Project	Mecklenburg County - County & Courts Office Building CCOB - Construction Project 2	Date	09.05.2024
Project Location	700 E 4 TH Street, 3rd Floor, Suite 300, Charlotte NC. 28202	Architect's Project Number	0596578102
Owner / Client	Mecklenburg County	File	6A This is page 1 of 3
To	Plan Holders List	Attention	Varies
Address	Varies		
City	Varies	State	Zip Code
Delivered via:	<input type="checkbox"/> Messenger <input type="checkbox"/> Hand carried <input type="checkbox"/> Facsimile <input type="checkbox"/> Express <input type="checkbox"/> Pick-up <input checked="" type="checkbox"/> E-mail Address <input type="checkbox"/> Mail <input type="checkbox"/> UPS <input type="checkbox"/> Website Address		
<p>This Addendum will become part of the Contract Documents. The Contractor shall promptly inform subcontractors and all others performing or supplying any of the Work of all relevant contents of this Addendum. In case of conflicting provisions with previous addenda or communications, provisions in this Addendum supersede only those conflicting issues. It is the responsibility of the Contractor to notify all subcontractors from whom it accepts bids of all changes in the drawings and spe

CONCRETE SIDEWALKS

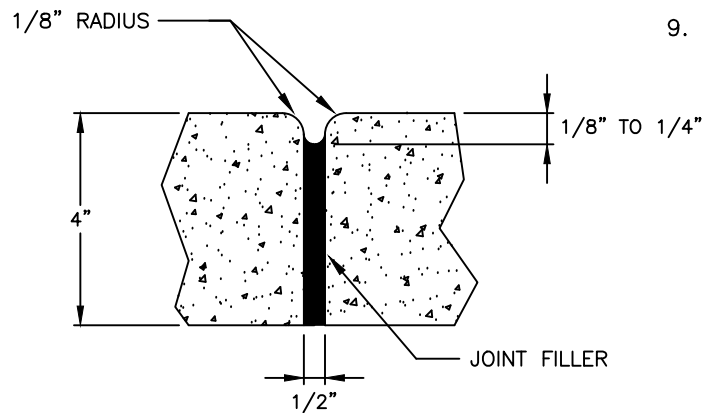
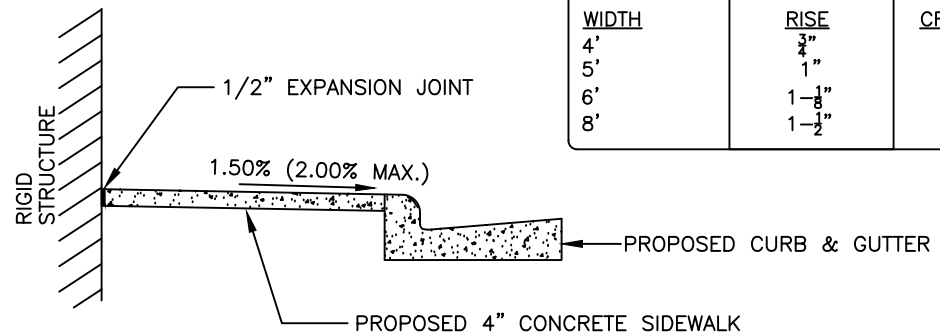
RFI #	RFI Question	RFI Response
1	Please provide a civil/site drawing for the work to be completed at the exterior of the building.	No Civil drawings to be provided. Exterior conditions are documented on Architectural drawings. Refer to enclosed "RFI-1_Concrete Sidewalks LDS 1022" document for additional information.
2	Please provide exterior elevations for the work to be completed at the exterior of the building.	Please see 01/A5.304.
3	Please confirm floor finish required at stairwells. Detail 7 on drawing A5.301 calls for PT08 at all stair landings and treads however Detail 5 on drawing A6.301 notes tread finish to be RT01.	See revision to Detail 5 on drawing A6.301.
4	Please reference specs section 087100 2.3. Specifications state that all lever sets are to best match each building's standard. Can you provide information on the existing locksets? Manufacturer, trim style, any other information for it?	There is no building standard. All manufacturers listed in specifications are acceptable. Most recent project in the building utilized Corbin-Russwin series ML-2000. Lever 110 with T Rose Escutcheon in 626 finish satin chromium plated.
